STAFF REPORT 06-09-2021 MEETING PREPARED BY: G. LANDSBERG

APPLICATION NUMBER: 21-7307

ADDRESS: 858 EDISON

SCOPE: NEW PROPOSAL TO REVISE PREVIOUSLY APPROVED ADDITION, PER WORK

View of existing conditions at rear, view to the south. Applicant photo.

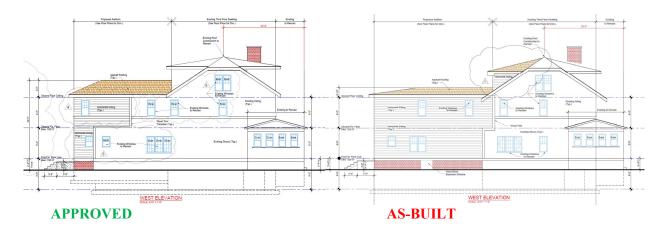
Currently, the property has a mostly-built rear addition that differs from the approved drawings in several ways, which are outlined under staff observations.

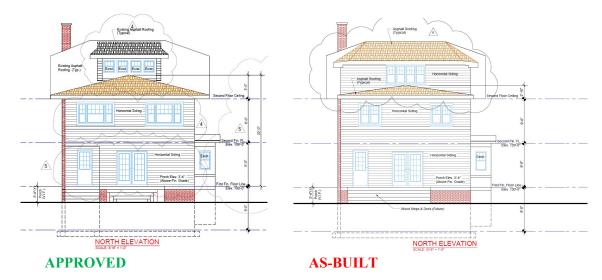
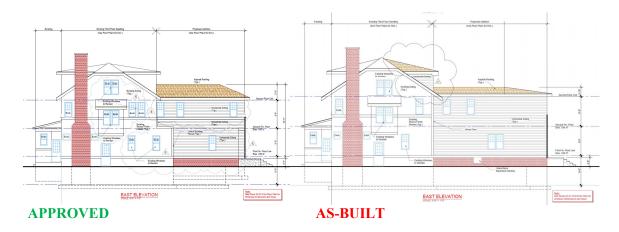
- O The addition was built fully 6'-6" longer (i.e., deeper into the rear yard) than what was approved. Additionally, the "transition line" between the addition and the historic material was moved substantially closer to the rear of the historic house, destroying historic fabric at the side which was meant to be preserved in order to keep the addition subordinate to the main house. The combined effect of both a longer addition and the truncated original house created a far more prominent addition than approved. Also, windows actually installed at the addition are simple 1-over-1 sash instead of the multilight windows as indicated on the elevations provided in both the approved and new submission.

- The rear dormer, an original historic feature of the home specifically identified for retention during the Commission's second review of the project, was removed. A far larger opening, aligned with the 1st and 2nd floor walls below, was created in the roof deck and a full-width rear-facing third floor was erected. This creates the effect of an additional 3rd story at the rear, rather than a true dormer, further destroying the character of the original house and amplifying the prominence of the addition.
- At the rear elevation, northeast corner, the inset alcove porch was not built as approved.
 Windows are different types and smaller.

- O A shallower roof pitch than approved is proposed. The roof overhang (eave) is also smaller than approved, further accentuating the inappropriately boxy quality of the built addition.
- The height at the top of the second story is 1'-0" taller than what was approved.
